# API 17 winter meeting update

## Mark Siegmund/John Allen

## DETAILS OF DIFFERENCES BELOW

Actual Process diagrams shown below.

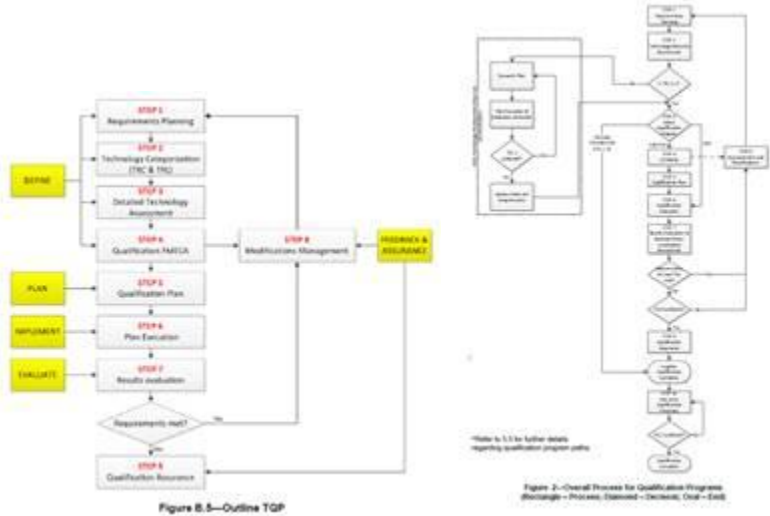
The process diagrams look very look very different, but the steps 1 to 9 are reasonably close in intent and 17Q has an additional step 10. Wording comparison below and differences highlighted in red

One of issues that evolved quite a bit as a result of discussion was the approach to maturity assessment. The version now in 17Q is quite different from the version (figure E.2) that was in the 17N appendix E on Technology Qualification, but as the appendix is to be removed from N the conflict will be removed.
